TA-53
OP/1100
unit

**SUBJECT: RESPONSE TO TECHNICAL AREA (TA) 53, NE & NW
SURFACE IMPOUNDMENTS (FORMER OPERABLE UNIT
1100)**

**RESPONSE TO TELECON COMMENTS
OF JANUARY 24, 1995 WITH NMED**

Figure 2-3. Current Configurations of the TA-53 Surface Impoundments

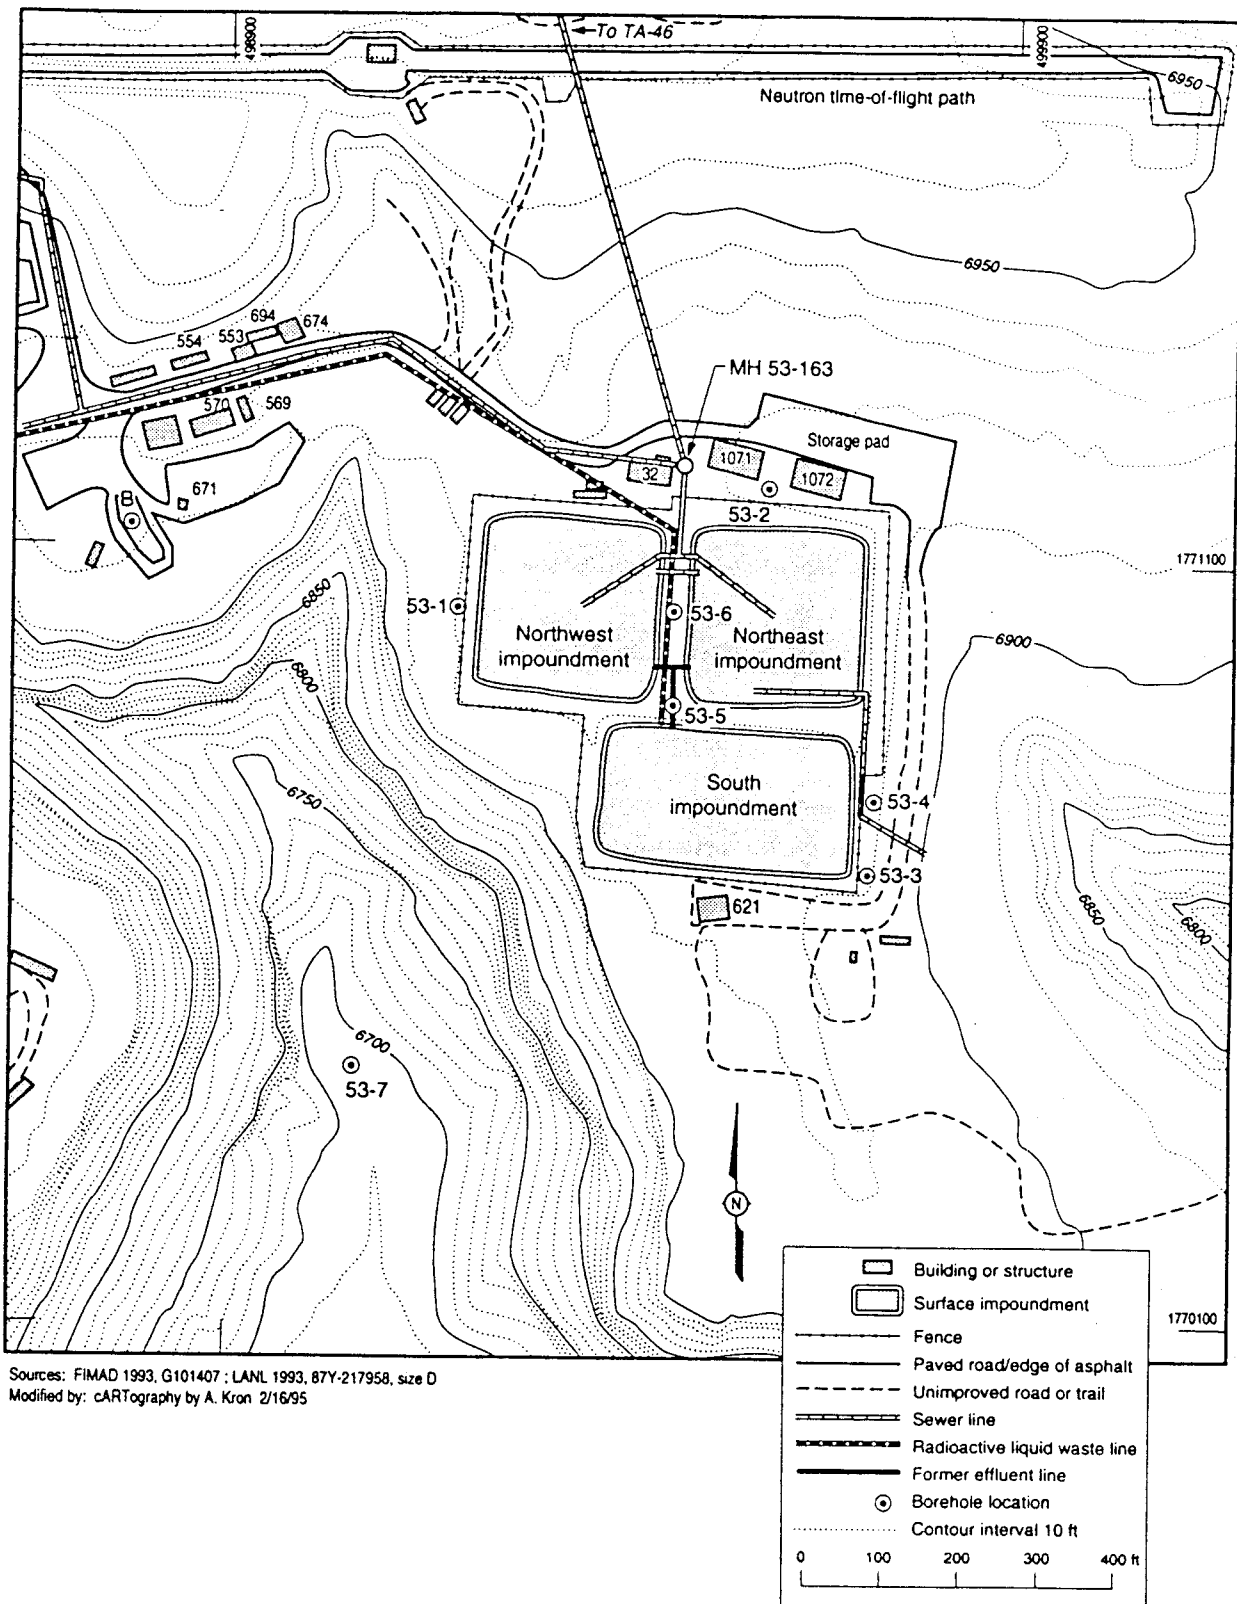
Comment 3. Clarify the locations and extent of discharge lines from the surface impoundments in the Closure Plan.

Revision 0 of the TA-53-166 NE and NW Closure Plan, Figure 2-3, incorrectly indicated the location of the NE and NW surface impoundments discharge line to the SE, and indicated manhole and lift station locations. The figure was revised in Revision 1 of the TA-53-166 NE and NW Closure Plan to correctly show the discharge line to the SW, and deleted manhole and lift station locations. Prior to construction of the south impoundment, the NE and NW impoundments discharged

to the south as shown in figure 4-1. Figure 2-3 has been corrected to show the correct location of lines entering and discharging from the impoundments at a larger scale. The Closure Plan will address the possibility of contamination as a result of leakage from the original south discharge line.
